Technical Service Information

JR403E SLIPS IN 2ND, 3RD, 4TH GEAR AND/OR NO UPSHIFTS, OR FALLS OUT OF 4TH HOT

Figure 1

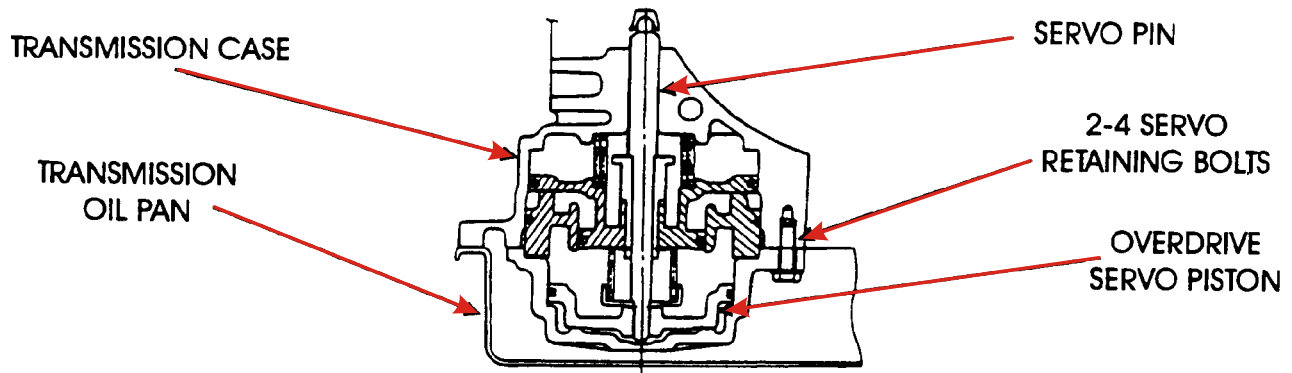
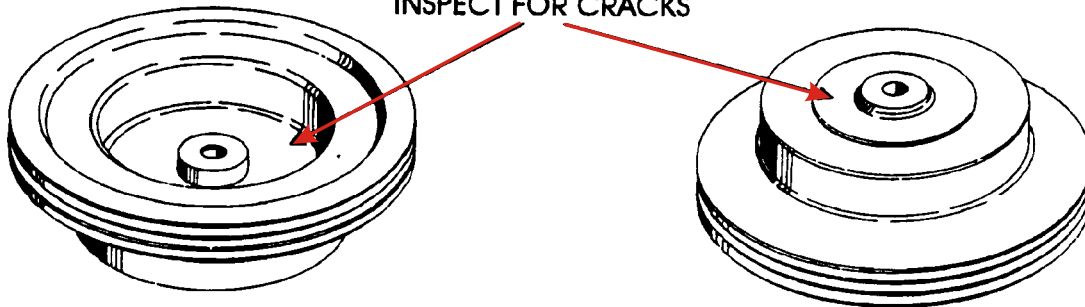
CAUSE: The cause may be, the bolts that retain the servo assembly to the main case were fractured and allowed the servo assembly to fall out of it’s bore and to rest on the oil pan. This action could result in “Major” pressure losses to the servo and could cause an alignment problem with the servo pin and the O.D. servo piston causing it to possibly crack (See Figure 1).

CORRECTION: There is now available from Isuzu, Grade 9 servo retaining bolts to replace the previous Grade 7 retaining bolts, and should be replaced on every JR403-E transmission regardless of the vehicle in which it is found. They are available under Isuzu part number 8-97 107-000-0. Check and replace the overdrive servo piston as necessary (See Figure 1).
